Product Change Notification / LIAL-19BORP399

CCB 3700.005 Final Notice: Qualification of a new components U2 and U6 for ATSAMA5D27-WLSOM1 Atmel catalog part number available in 188L module (40.8x40.8x3.3mm) package at MMT assembly site.

U2 and U6 Components Location

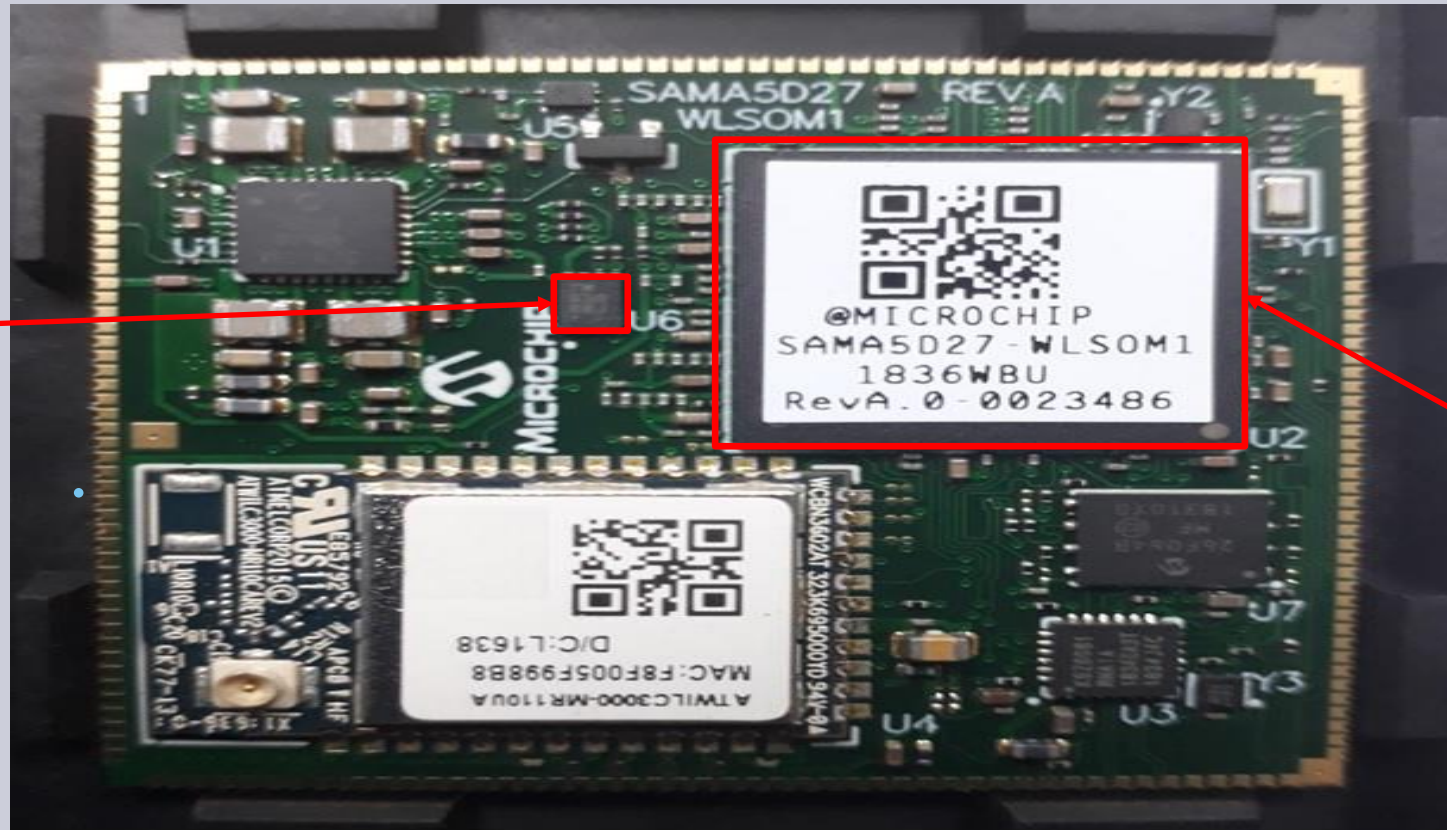
Description of Change:Qualification of a new components U2 and U6 for ATSAMA5D27-WLSOM1 Atmel catalog part number available in 188L module (40.8x40.8x3.3mm) package at MMT assembly site.

ATSAMA5D27-WLSOM1 module package	Using an old version component U2 with an old Chip ID 0x8A5C08C2 and U6	Using a new version component U2 with a new Chip ID 0x8A5C08C4 and U6
	See attached photo for U2 and U6 location
